# Groundwater Application Review Summary Form

Application # G- 19153 [#####]

TO: Water Rights Section Date 01/30/2023  
 FROM: Groundwater Section Darrick E. Boschmann  
Reviewer's Name  
 SUBJECT: Application G- 19153 Supersedes review of 12/01/2021  
Date of Review(s)

**A. GENERAL INFORMATION:** Applicant's Name: Hermreck at the Y Ranch County: Crook

**Well Location Map**

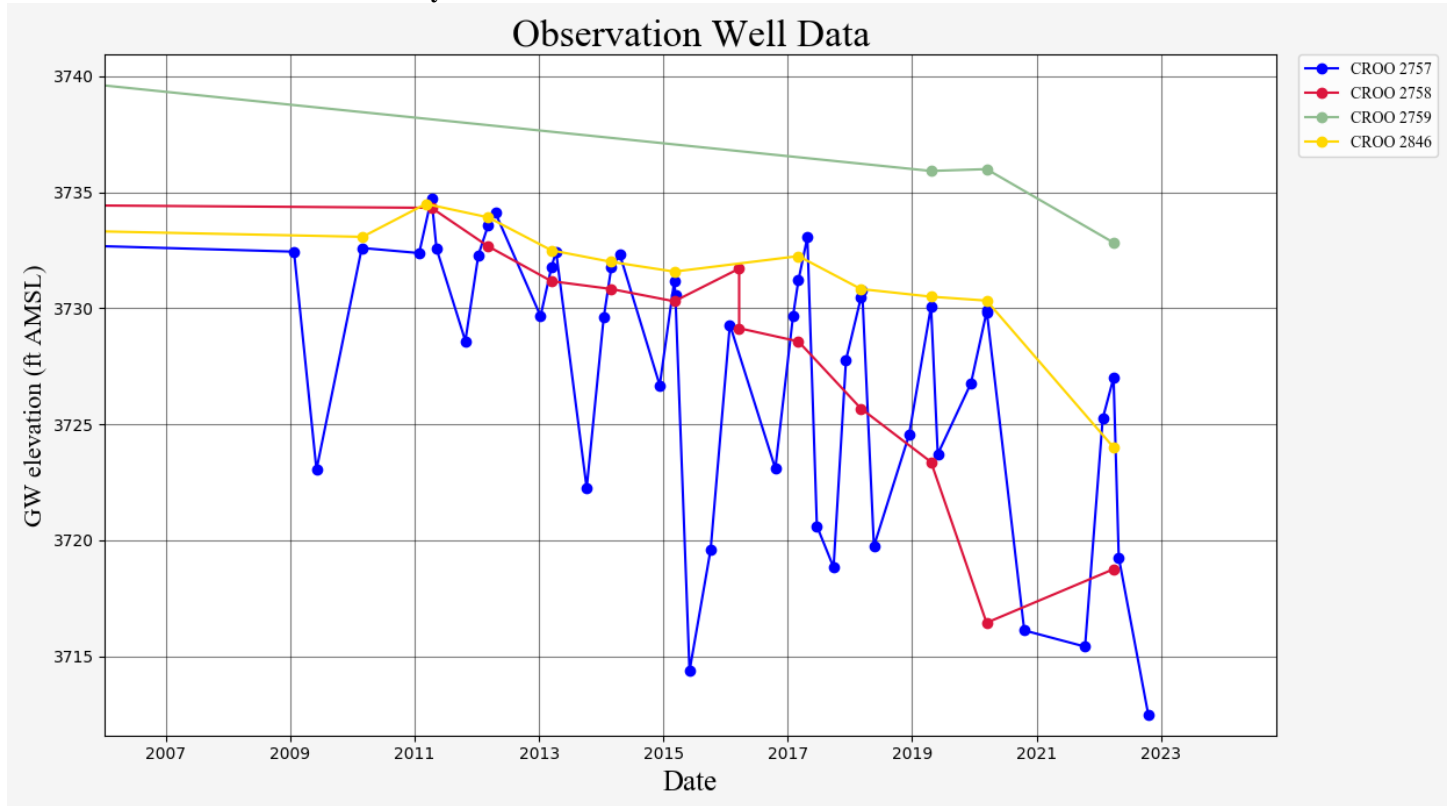
Water level data for wells completed in basalt in this area show a consistent decline over approximately the past decade. It cannot be determined with certainty if some portion of this decline might be attributed to climate.

Even with the rate of decline occurring in this area it is not likely that any interference with nearby wells would meet the standard for substantial or undue interference.

The available water level record does not meet the Division 8 definition of excessively declining or declined excessively (for the storage portion of the source of water to wells).

If a permit is issued for this application the following conditions should be applied:

- 7N
- 7J
- Medium water use reporting
